WATER RESOURCES ADVISORY BOARD MEETING

MEETING DATE: Monday, 18 May 2015

DATE: February 5, 2015 **ACE PROJECT NO.:** COBLDR16
TO: Katie Knapp, City of Boulder Planning and Development Department
FROM: Brian Van Zanten, Anderson Consulting Engineers, Inc. *BLV*
Greg Koch, Anderson Consulting Engineers, Inc. *GK*
SUBJECT: Peer Review – Skunk Creek, Bluebell Canyon Creek, and King’s Gulch Request for Physical Map Revision Report, Boulder, Colorado

This letter provides responses to the comments provided by Anderson Consulting Engineers as part of their peer review regarding the Skunk Creek, Bluebell Canyon Creek, and King's Gulch Request for Physical Map Revision – Hydraulic Report, dated August 1, 2014. A revised Hydraulic report will be provided under separate cover.

Skunk Creek, Bluebell Canyon Creek, King's Gulch
 Request for Physical Map Revision (PMR)
Figure 4.4: Floodplain Workmap

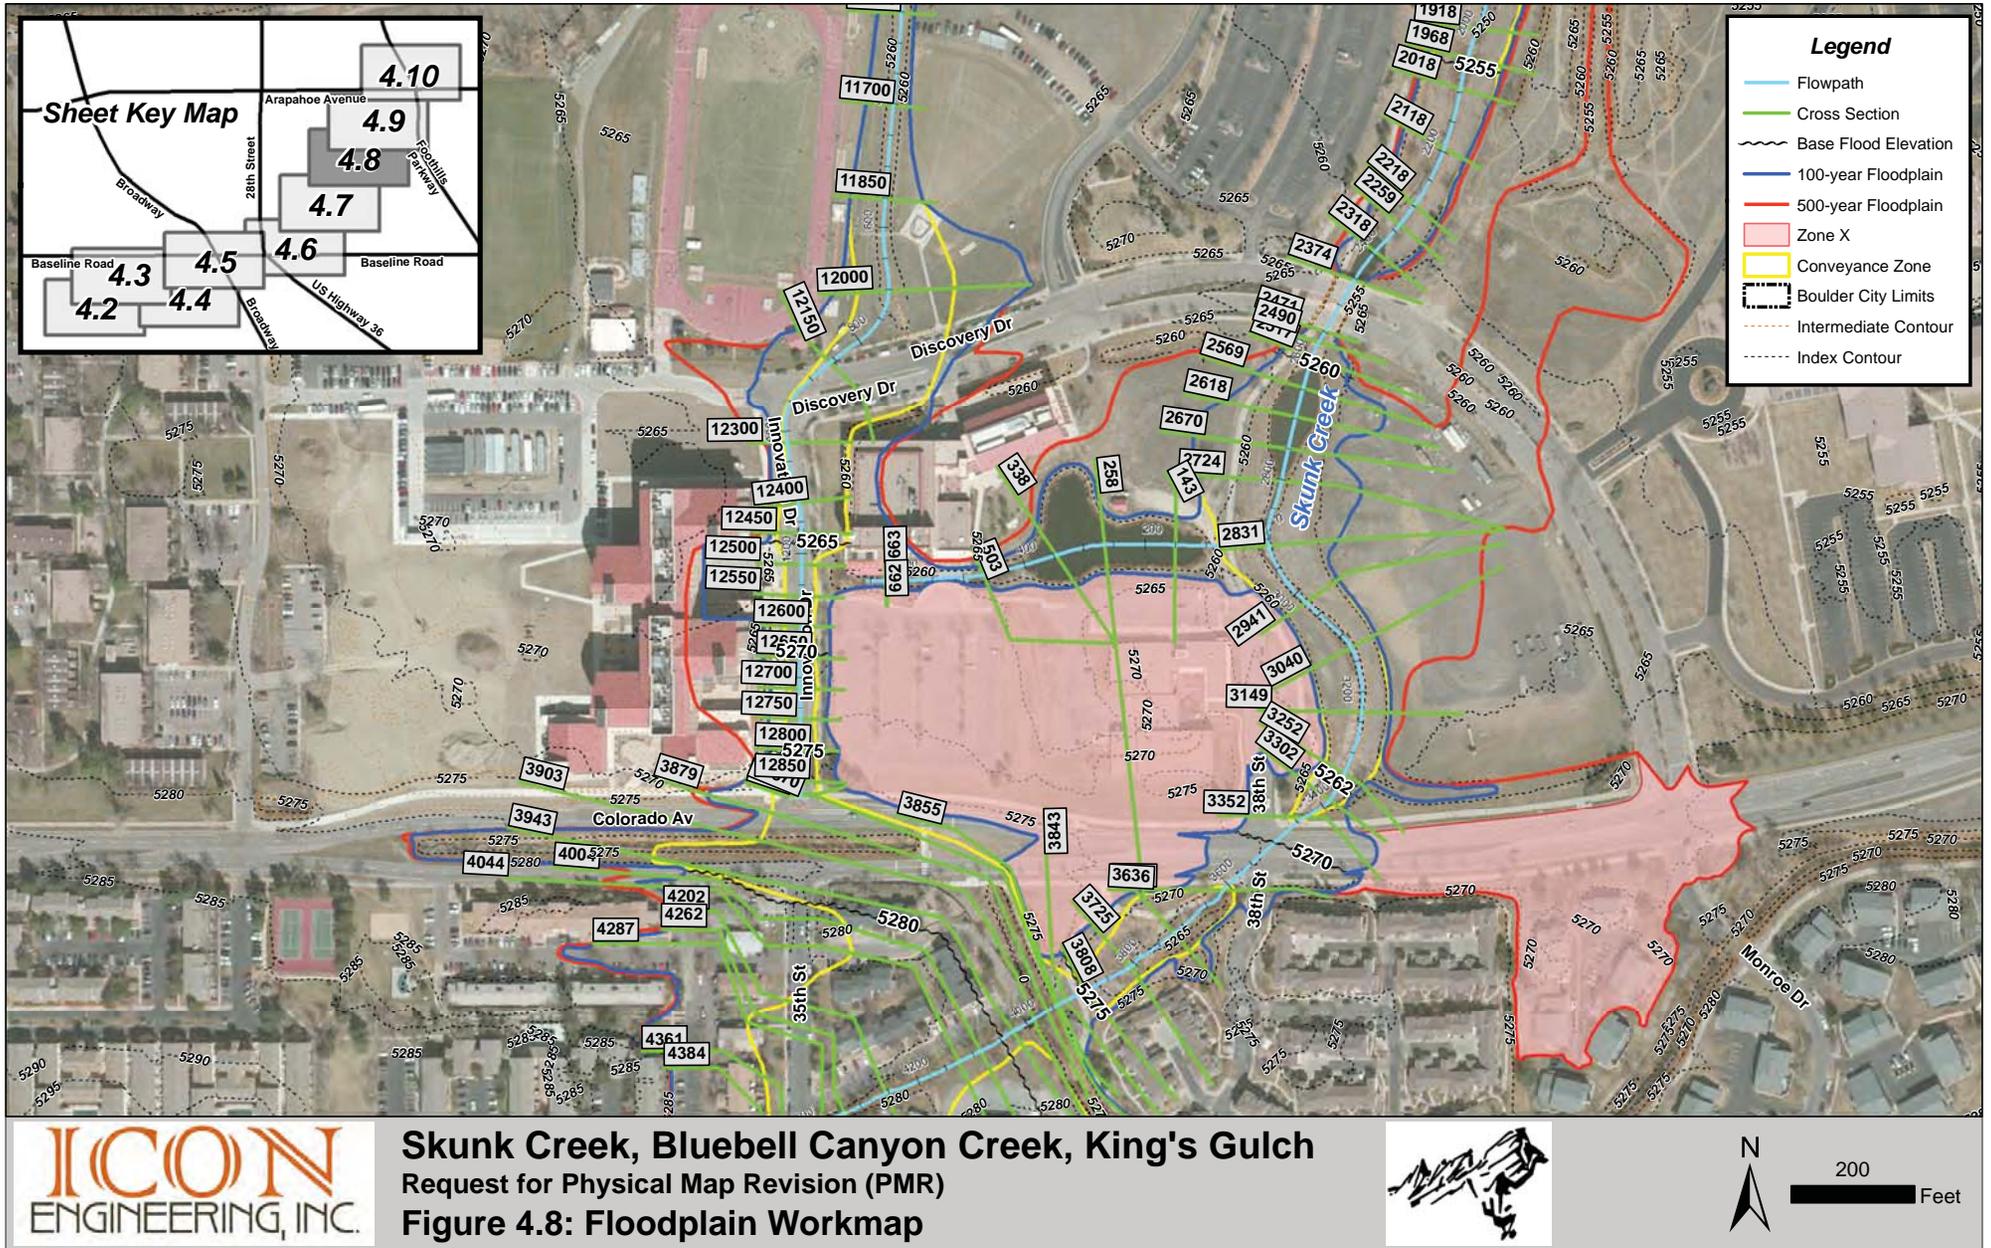
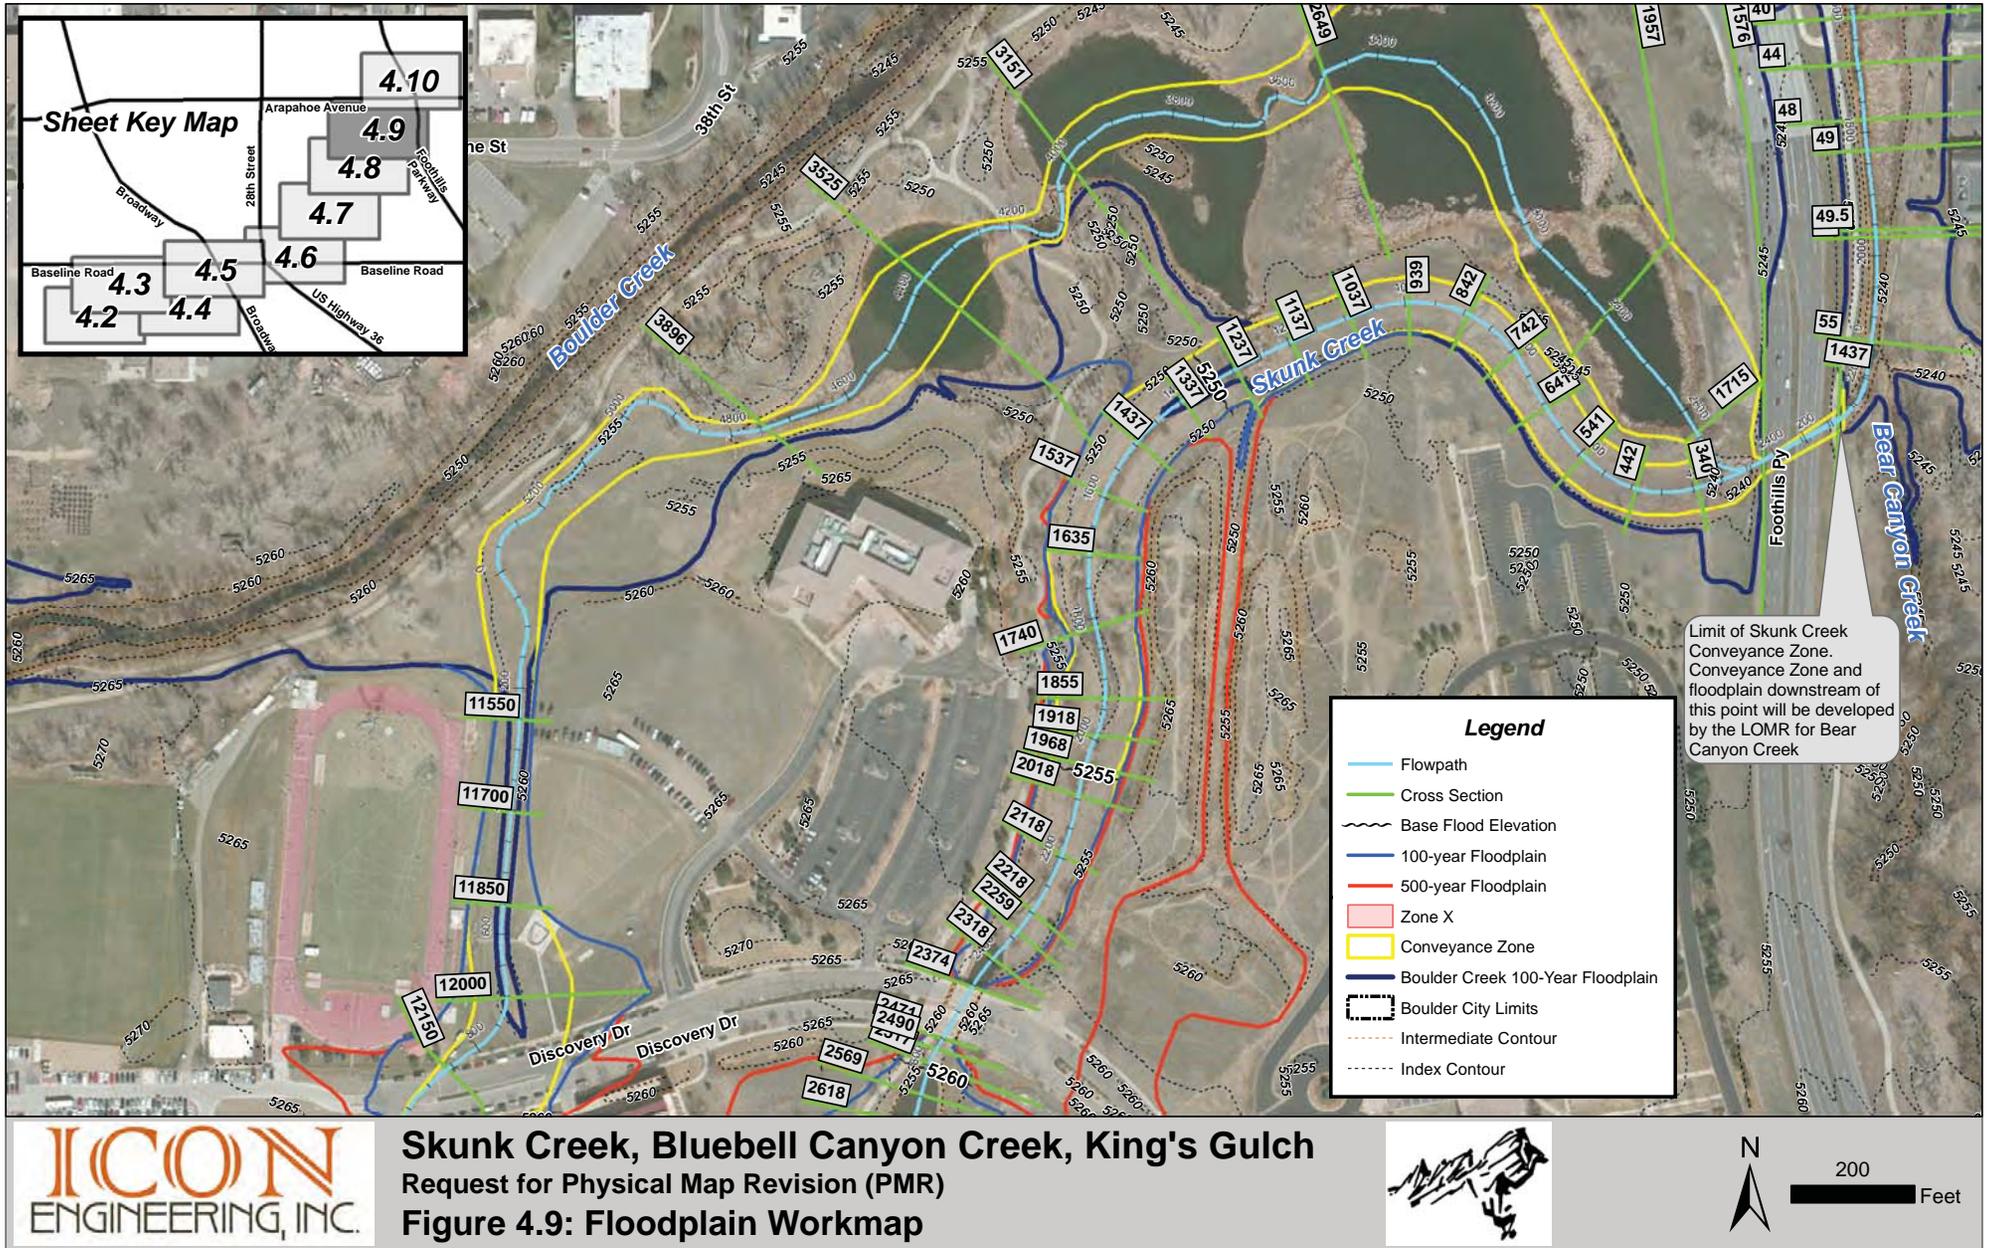
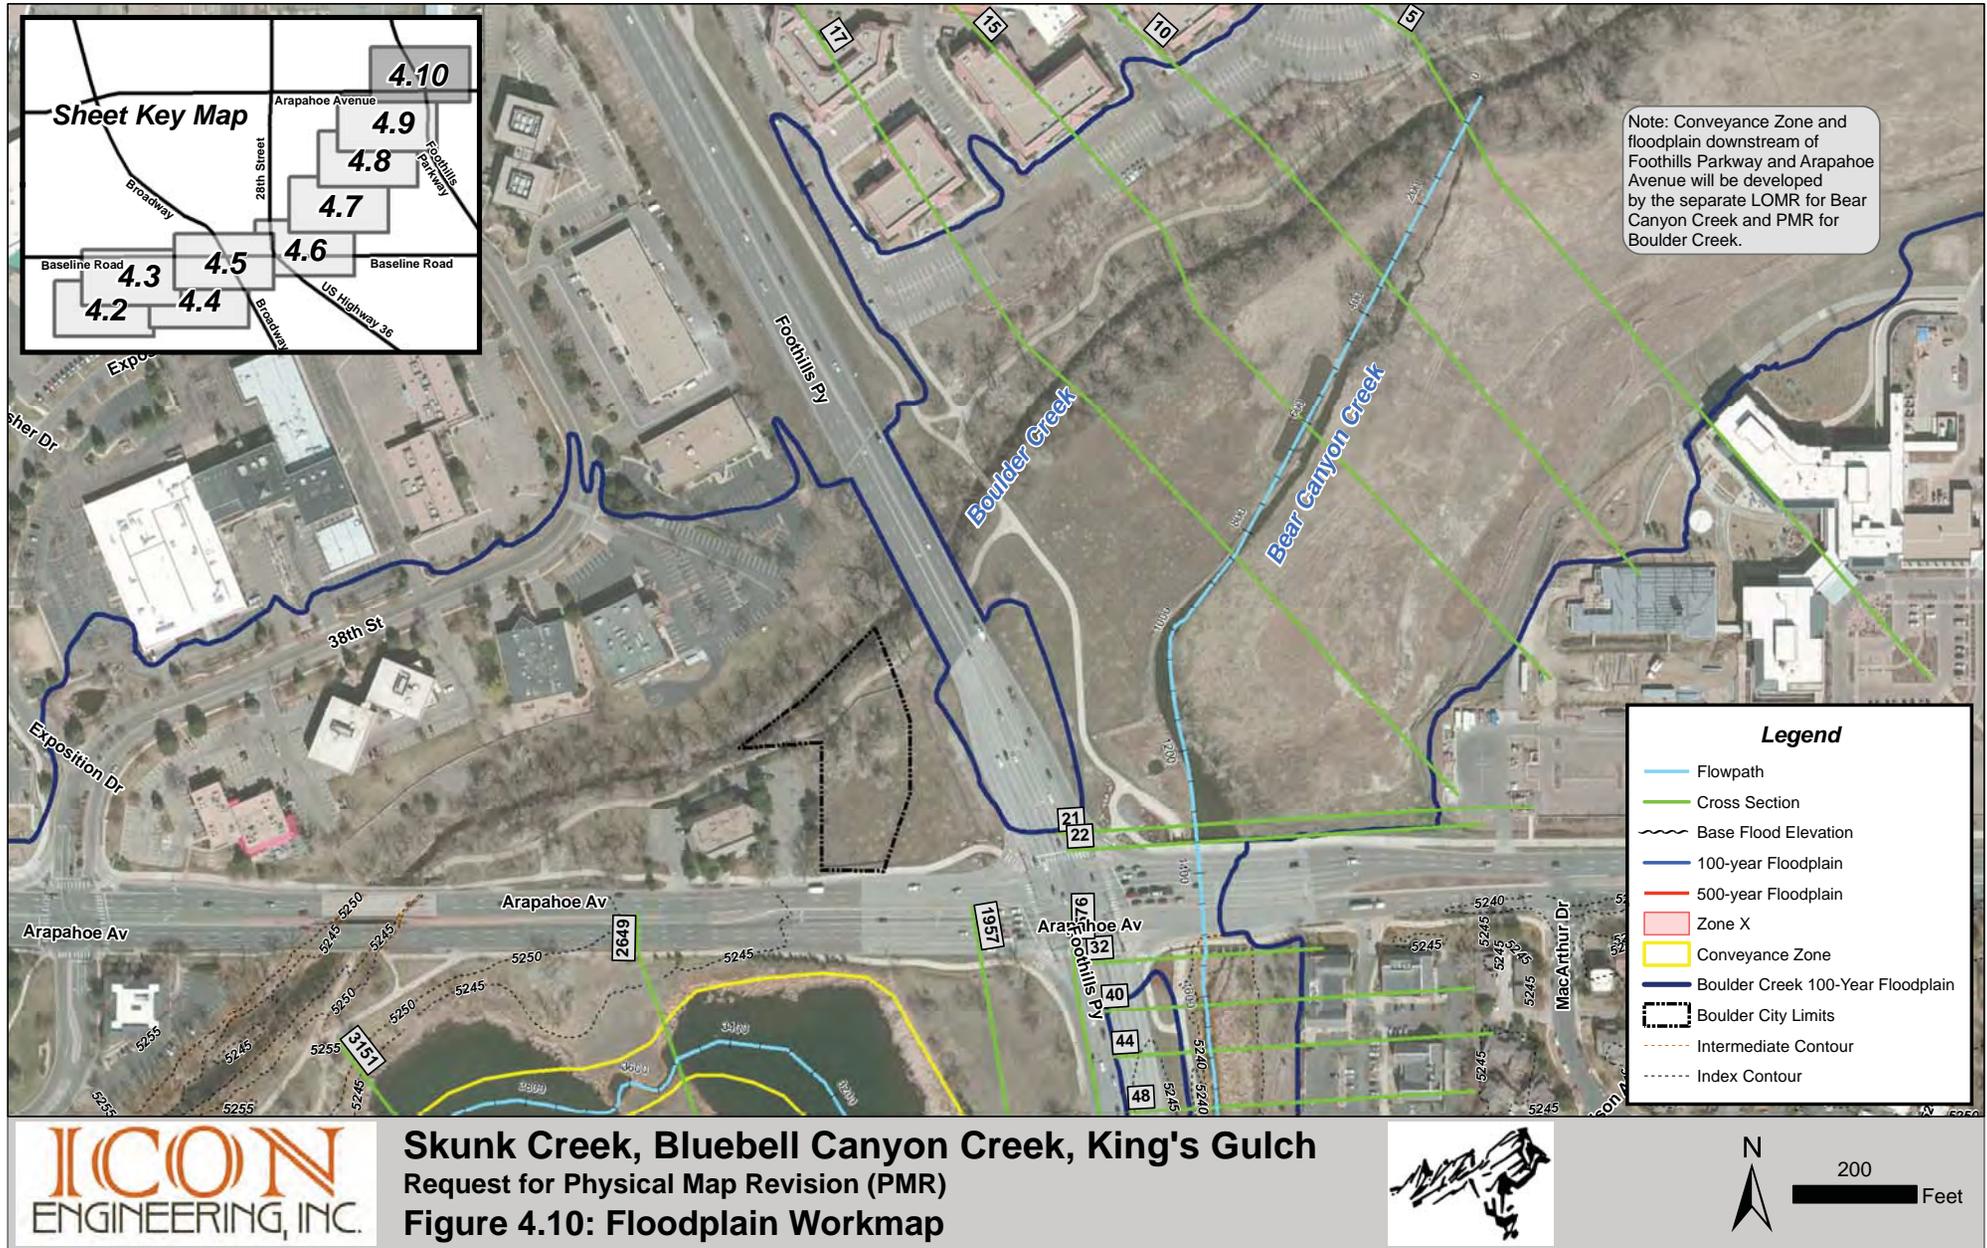
- (1) According to the HEC-RAS model, 100-year flows begin spilling over the left overbank on the main Skunk Creek flow path downstream of Cross Section 1437. Figure 4.9 depicts the 100-year floodplain boundary extending past this point to Cross Section 1237. Please revise as necessary.

- 51. According to the HEC-RAS model, 100-year flows begin spilling over the left overbank on the main Skunk Creek flow path downstream of Cross Section 1437. Figure 4.9 depicts the 100-year floodplain boundary extending past this point to Cross Section 1237. Please revise as necessary.**
